Amendment to Highest Output Power

We re-issued FCC test reports with the amendment of the highest output power in the current MC8795V FCC report (I09GW6944-FCC-EMC-2 and I09GW6944-FCC-MPE-3).

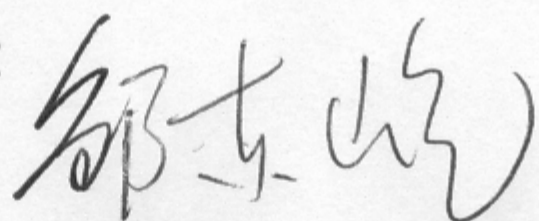
The reason for the amendment of the highest output power as below:

- 1, the peak power of PCS1900 band (GPRS 1 time slot) in the current test report is the average power; we should revise it to the peak power.
- 2, the peak power of PCS1900 band (EGPRS 1 time slot) in the current test report is the average power; we should revise it to the peak power.

After we issued the current test report at that time and later we found the value's issue, So we re-issued the test reports to the customer.
